PROPOSED
SELF SERVICE STORAGE
SITE PLAN

STORAGE 4 LESS
CLASS 3 SITE PLAN REVIEW
TAXLOT 2400
MAP 75 3N 35BD

22nd Storage

SUBJECT: PUBLIC WORKS RECOMMENDATIONS
SPR-ADJ 19-19 (19-107583-RP)
1805 22ND STREET SE
STORAGE BUILDINGS

SITE PLAN
SCALE 1"=50'

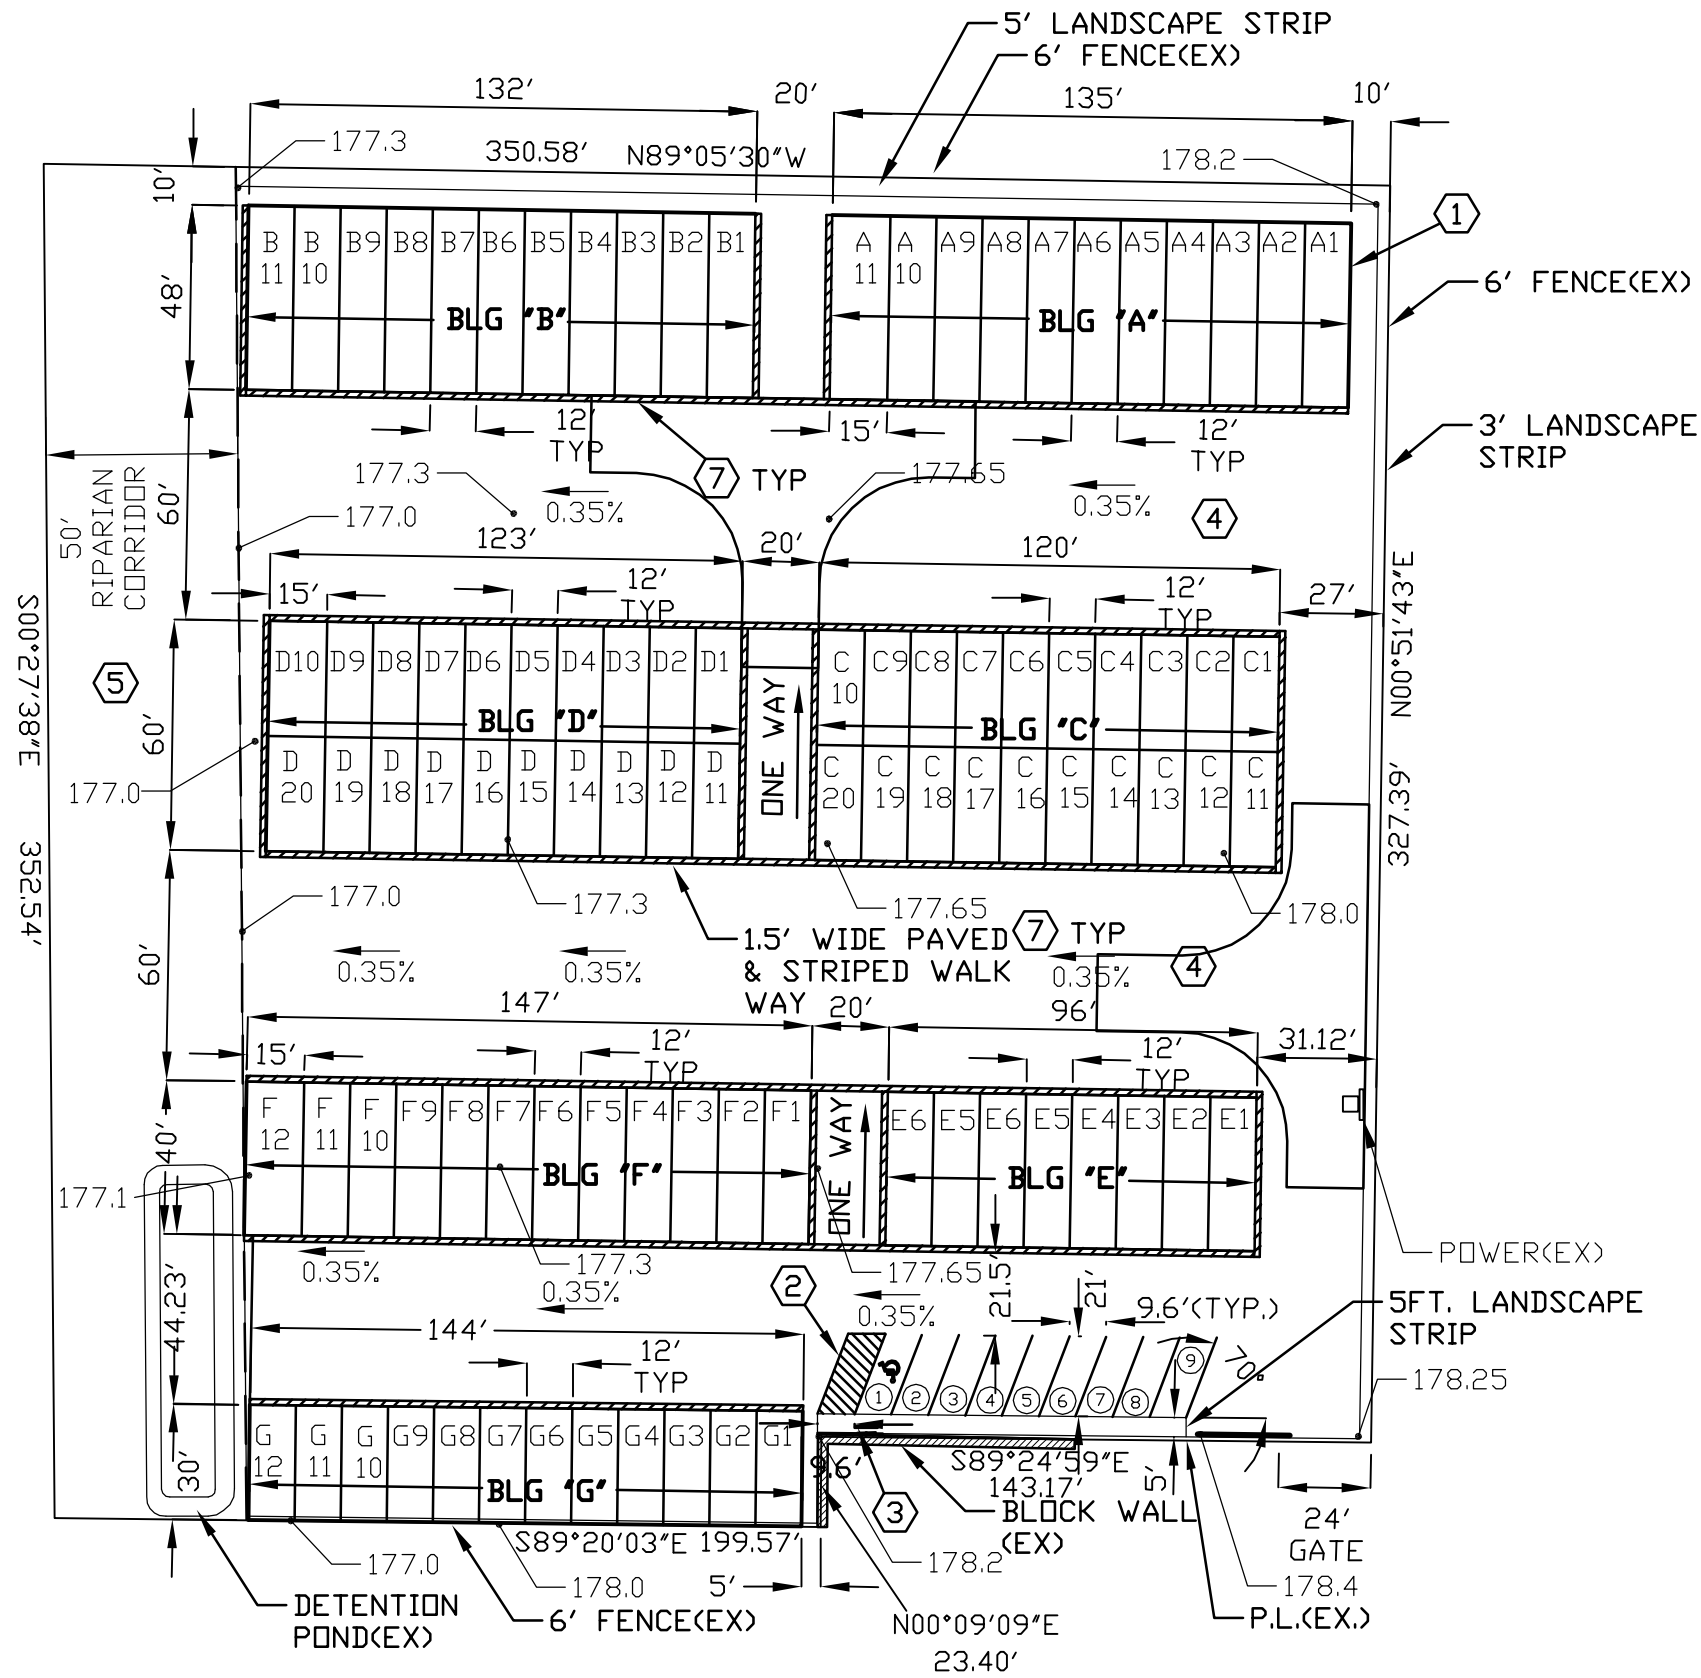
1. Dedicate an open channel drainage easement along the portion of Pringle Creek adjacent to the western boundary of the subject property. The appropriate easement is the greater of 10 feet from the top of the bank, 15 feet from the centerline of the creek, or the 100-year floodway.
2. All new structures shall be built in compliance with the standards set forth in the Floodplain Overlay Zone Ordinance, SRC Chapter 601.
3. The building footprint for Building G shall be located entirely outside of the floodway boundary.

The proposed site plan does not provide sufficient details to demonstrate that the proposed self-storage structures do not encroach within the existing floodway. The applicant shall modify Building G, if necessary, to remove the proposed encroachment in the floodway pursuant to SRC 601.040(b)(5).
